FEDERAL PROJECT NOS. CMAQ-STP-BUILD-5617(602)
BPS PROJECT NO. 2020-40-012

ADDENDUM NO. 2

20TH STREET MOBILITY IMPROVEMENTS

DATE: **9/3/24**

SHEET NUMBER
C2.2

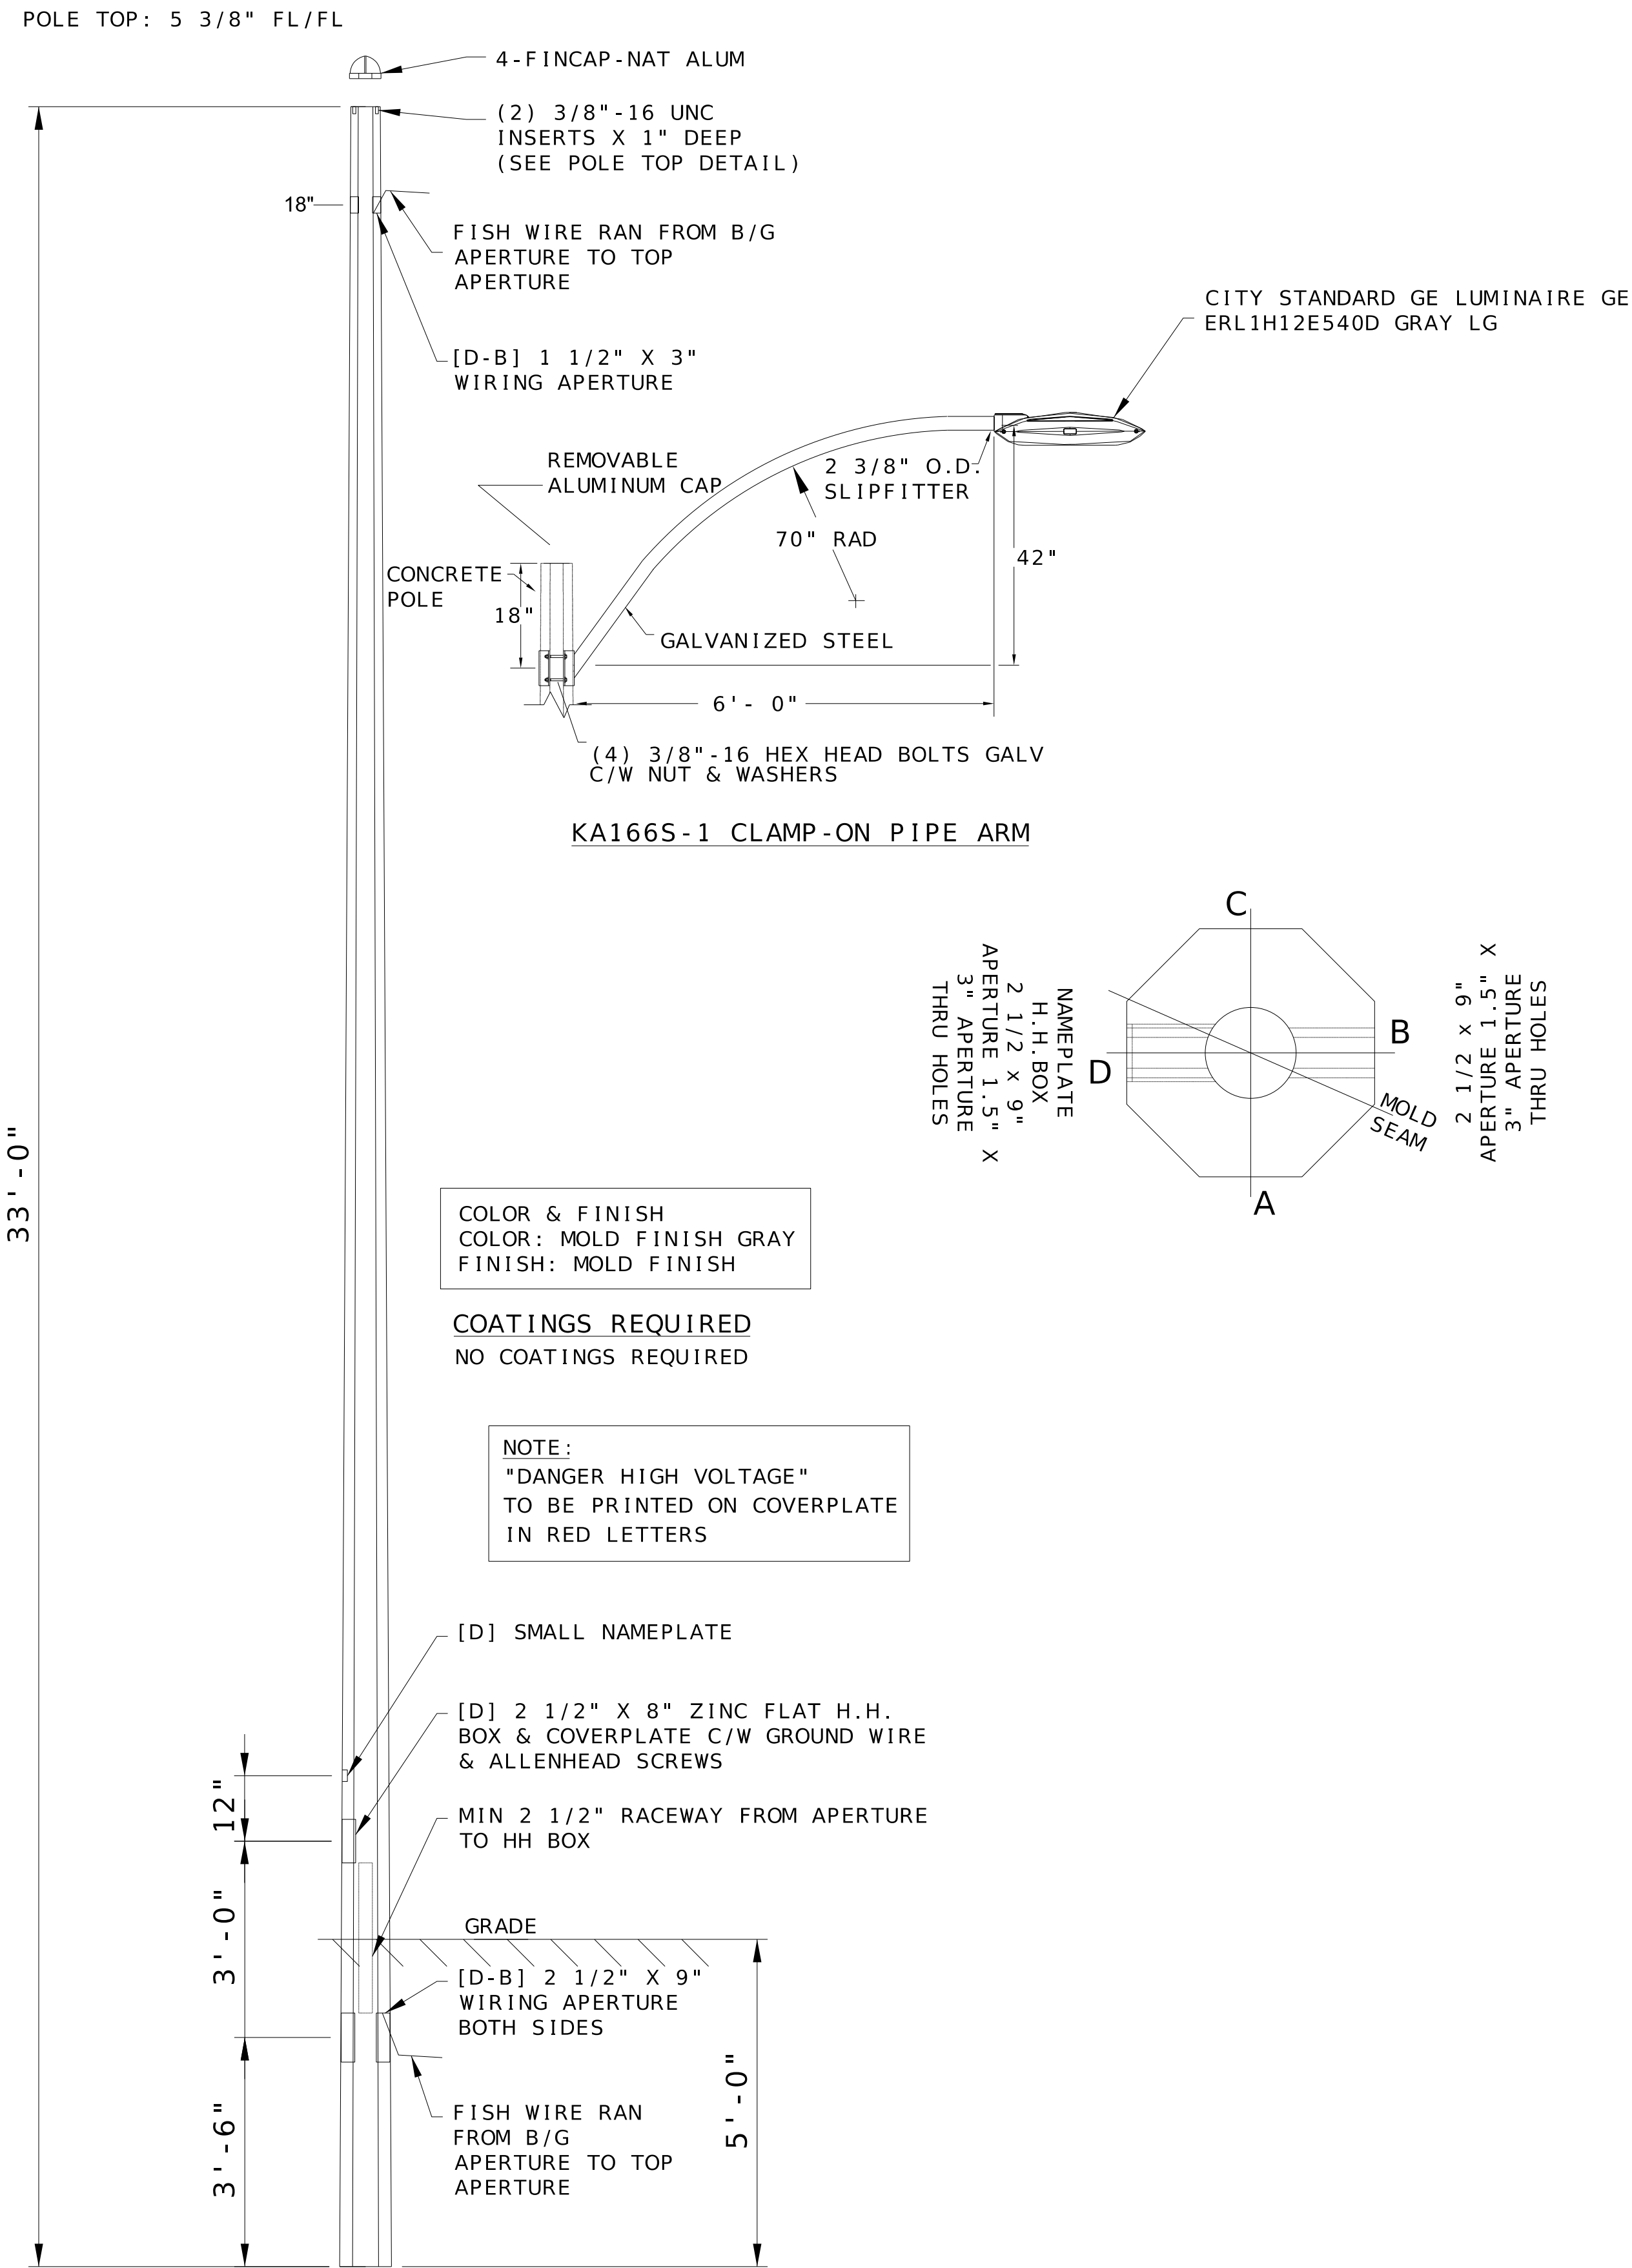
- **Sheet C2.2**: Image on the plan sheet has been revised to better represent the light poles.
- **Sheet LI-47**: Corrected catalog number of the light fixture.
- **Sheet C9.3**: Stationing and elevations at the northeast corner of the 20th/Locust intersection have been revised.

SHEET NUMBER
LI - 48

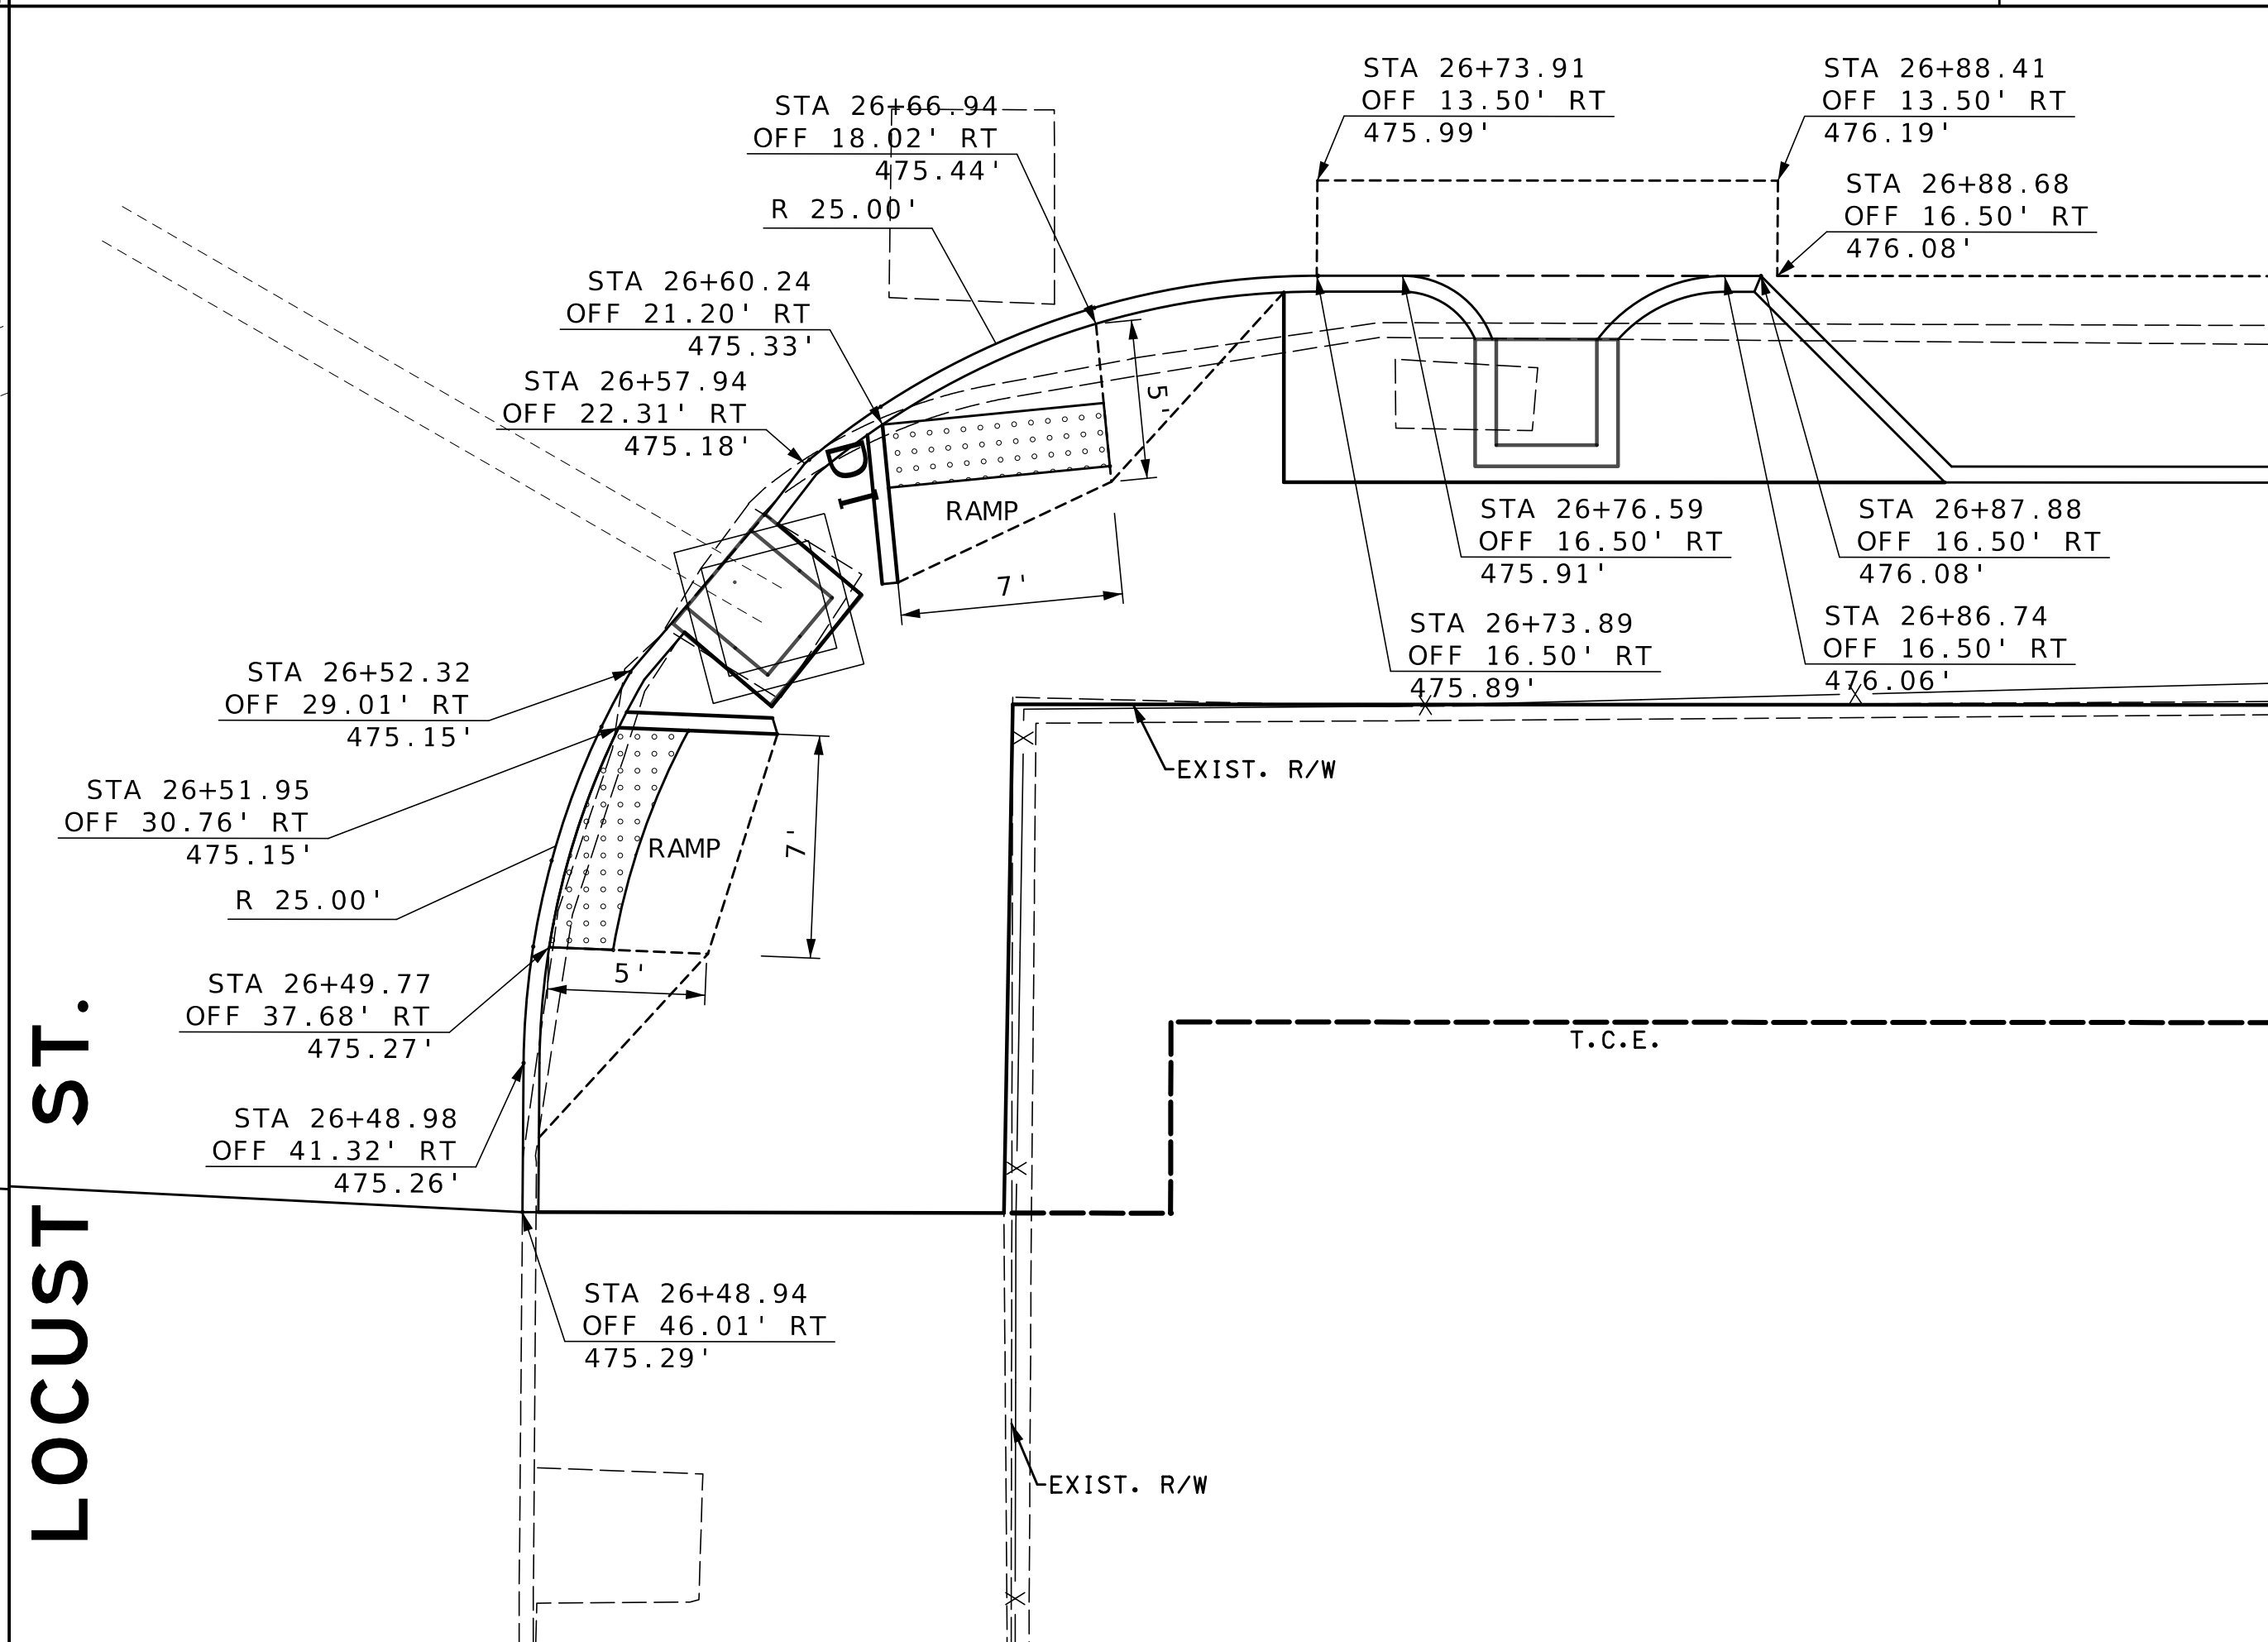
Q: JSP UUUU list different light poles and luminaires from what is shown on the plans.

A: The plans and JSP UUUU have been revised to show the correct catalog numbers of poles and light fixtures. There are no revisions to the bid quantities.
